HOWARD COUNTY HISTORIC PRESERVATION COMMISSION

November Agenda

This Agenda identifies the work proposed and includes comments and recommendations from DPZ Staff. The recommendations included here do not constitute a decision of the Commission.

Figure 2 - Proposed gate

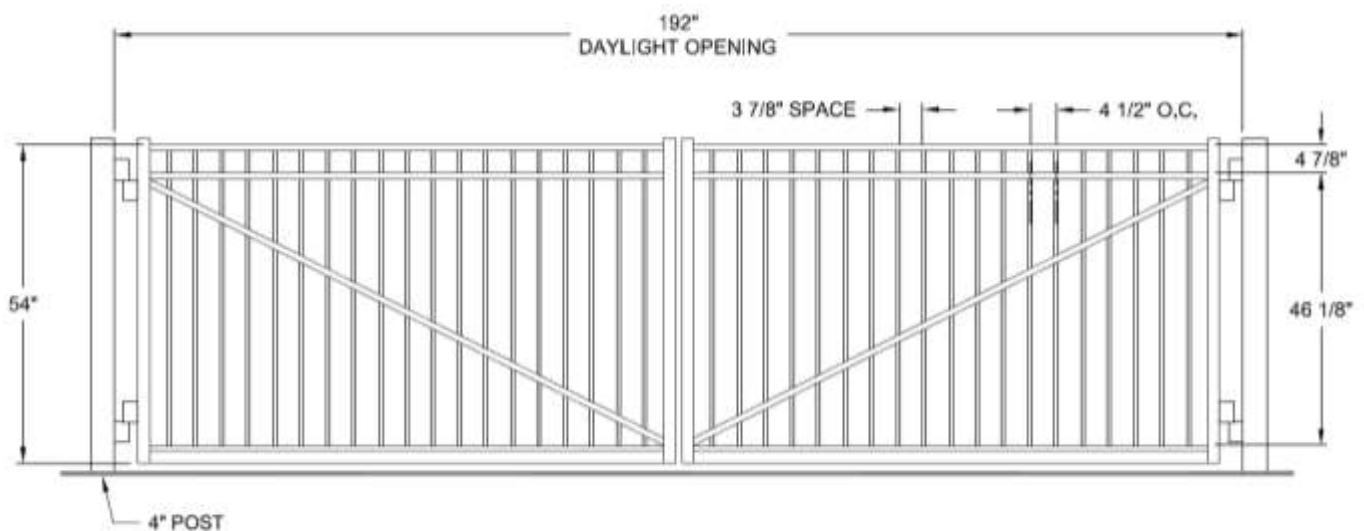
Staff Comments: Chapter 9.D explains, “retaining walls of granite, brick or timber may be appropriate depending on the context...new granite walls are expensive, but retaining walls faced with granite or with a surface treatment that resembles Ellicott City’s typical stonework can be appropriate in visible locations.” The replacement of the existing timber retaining wall with a stone retaining wall complies with Chapter 9.D recommendations, “construct new site features using materials compatible with the setting and with nearby historic structures, particularly for features visible from a public way.” The color and size of the stone that was used complements the historic stone found on the remainder of the retaining wall and in Ellicott City.

The black metal fence and gate will be a more historically appropriate fence than the existing chain link, as recommended by Chapter 9.D which states, “install open fencing generally not more than five feet high, of wood or dark metal.”

Staff Recommendation: Staff recommends Approval as submitted.

Figure 12 - Proposed trim around front door

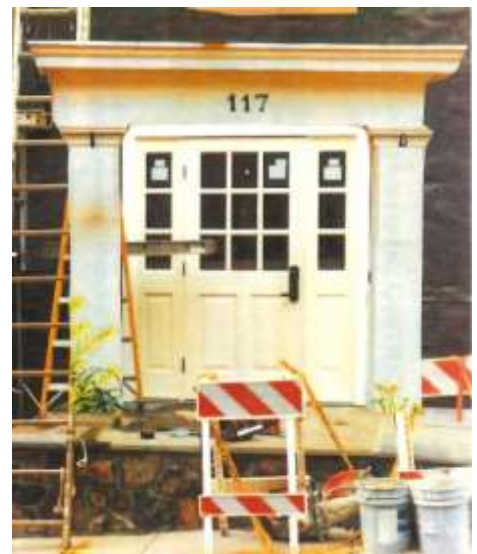
The previously existing sliding barn doors surrounding the front door have been removed, possibly for the siding repair. The doors are not shown on the mocked up image with the added door trim. The removal of this feature will require approval, in addition to any overhang that is installed.

Staff Comments: The proposed trim around the door is a Greek Revival detail that would not historically be found on a building of this utilitarian/agricultural style. Chapter 6.G of the Guidelines (page 38) recommends against, “using doors or door frames that are overly decorative, out of character with the style of the building. Staff recommends the Applicant consider an alternative style of overhang, such as the one shown in Figure 14. The overhang shown below is on a carriage house of a similar style to the subject building. The carriage house below also has sliding barn doors, similar to the subject building.

Staff Recommendation: Staff recommends denial of the proposed door trim as it is not an architecturally appropriate alteration for the building. Staff recommends retroactive approval of the replacement door.

Figure 20 - Proposed gooseneck lighting

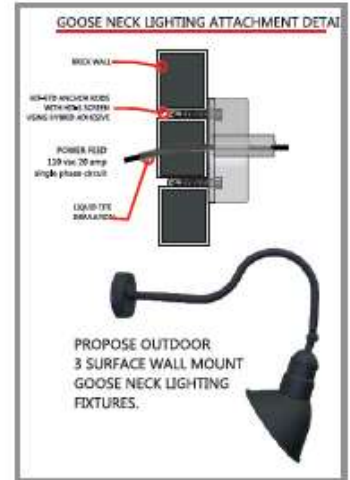
The proposed gooseneck lights comply with Chapter 11.A recommendations, “use indirect lighting or concealed light fixtures with concealed wiring to illuminate signs. If the light source will be visible, select a fixture compatible with the style of the building. Minimize glare by focusing the light on the sign.” The three gooseneck lights will be directed at the sign. The black metal fixtures also comply with Chapter 9.E recommendations, “use dark metal or a similar material.” The Guidelines recommend against using internally lit plastic signs, so the use of separate lighting fixtures as proposed complies with the Guidelines.

Staff Recommendation: Staff recommends Denial of internally lit signs. Staff recommends Approval of directory sign. Staff finds the flat mounted aluminum sign and gooseneck lights comply with the Guidelines, but recommends the sign be reduced in size and better placed on the building prior to Staff recommending approval.
